RE: the Burrillville Land Trust petitions US EPA Region 1 to conduct an Environmental Impact Statement for the Clear River Energy Center

UNITED STATES ENVIRONMENTAL PROTECTION AGENCY
PETITION FOR AN ENVIRONMENTAL IMPACT STATEMENT ON THE
PROPOSED CLEAR RIVER ENERGY CENTER

**PETITION TO US EPA REGION 1 TO CONDUCT AN ENVIRONMENTAL IMPACT
STATEMENT ON THE PROPOSED CLEAR RIVER ENERGY CENTER**

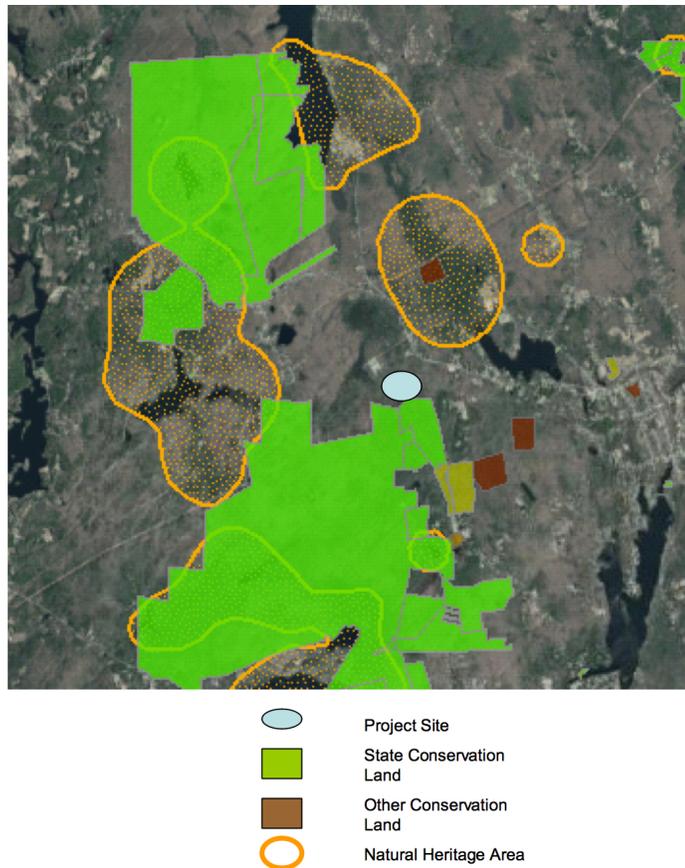
Many of the questions that need to be asked (and answered) reflect the overall impact of shrinking a significantly-sized tract of forest and the resulting on-site impacts, but more importantly the extent of those impacts off-site into the surrounding landscape. As a guide for the EFSB, see Figure 1 which shows the landscape context within which the project site is located, along with identification of conservation lands within a several mile radius, and Natural Heritage areas (identified habitats for Rhode Island rare species). Its important to note here that the Burrillville Land Trust owns properties in the following tracts (some of these properties are shaded in dark greenish yellow and brown on the map shown below). The properties include the following:

Natural Heritage Areas include known occurrences of state and federal rare, threatened and endangered species. The polygons in Figure 1 depict the estimated extent of rare species populations, although in most cases inventory and habitat assessments are needed to accurately determine the current status of individual populations.

Please note that there is no indication that the consultant requested information regarding the presence of rare species on site or within a reasonable distance of the project by consulting the Natural Heritage database²³, or any other reference. If they did request the information, they did not include the information in their report or in the application.
